**Subject: Major Amendment to PD, Development, & Design Review – Harbour Cay Phase II
Technical Review Project # 21-07000005**

**RE : Harbour Cay Phase II (Harbour Isle Shoppes) – 835 Seaway Dr.
 Planned Development Minor Amendment
 TRC No. 21-07000005**

Rezoning, Development Review, & Design Review – Harbour Cay Phase II

TECHNICAL REVIEW PROJECT # 21-07000005

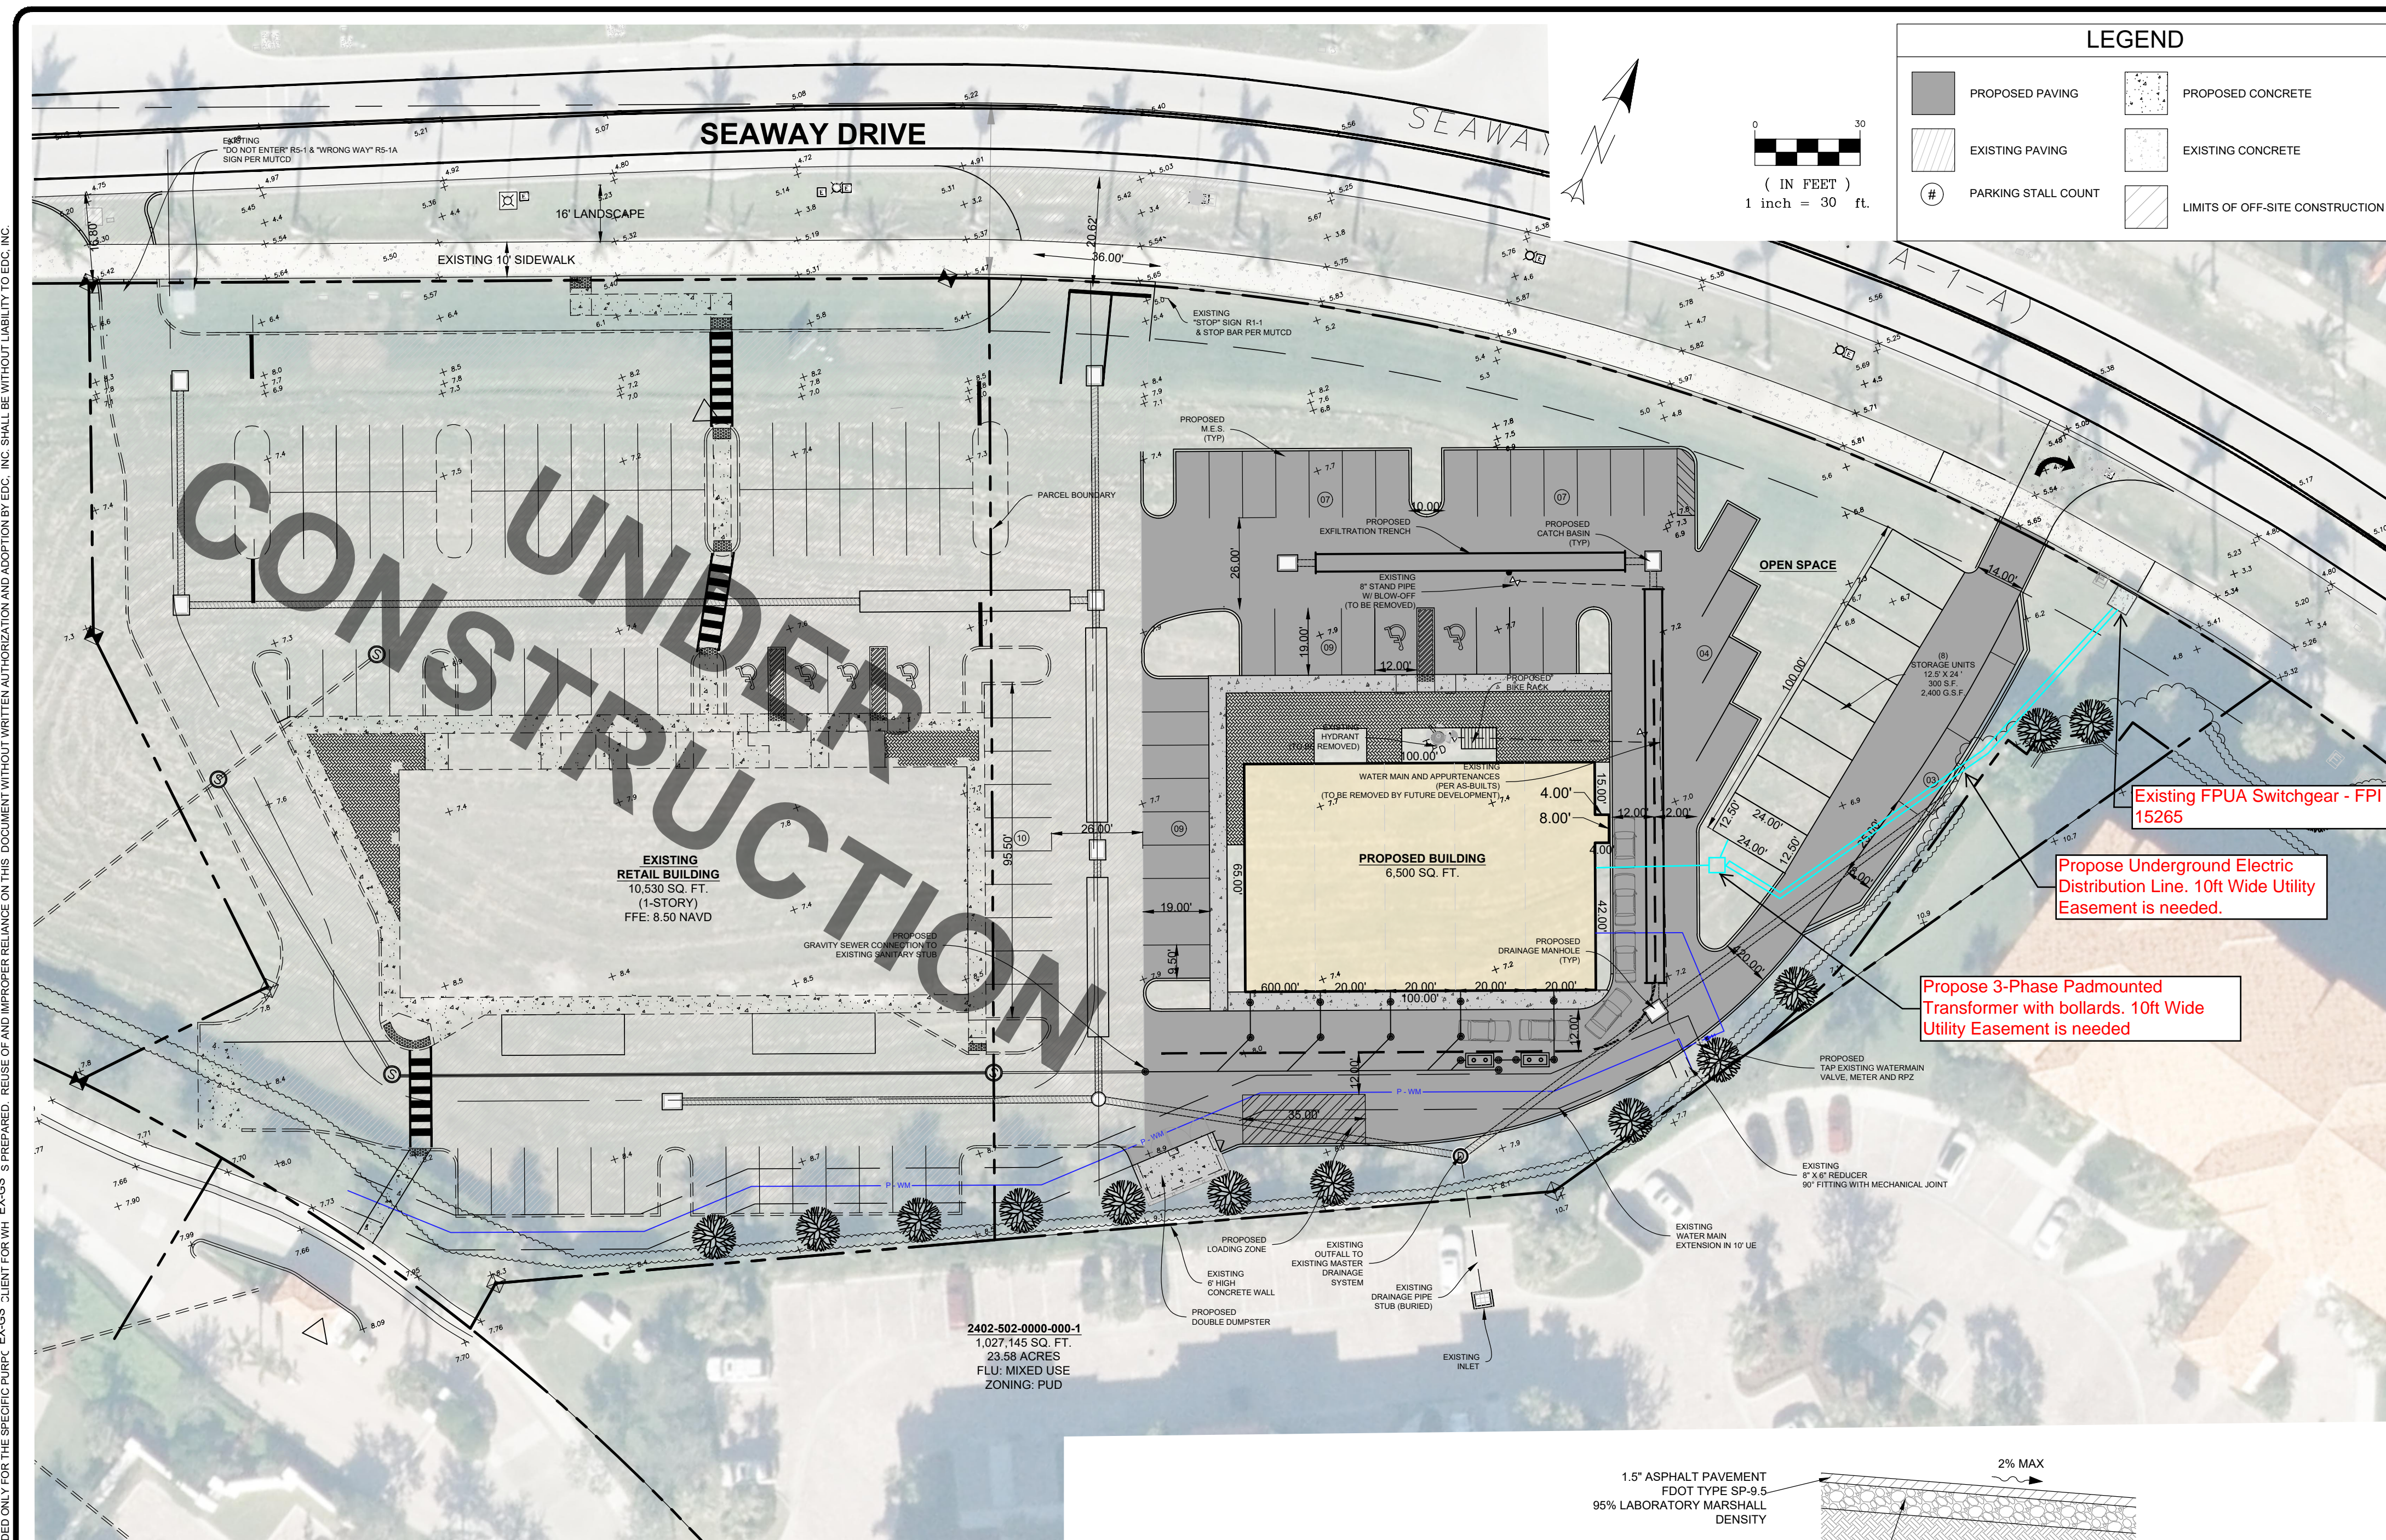
Utility easement will be required for all propose FPUA electric facilities within the site.

Please find attached the markup consultant plan, showing FPUA existing electric and our propose location for the new electric facilities within the site.
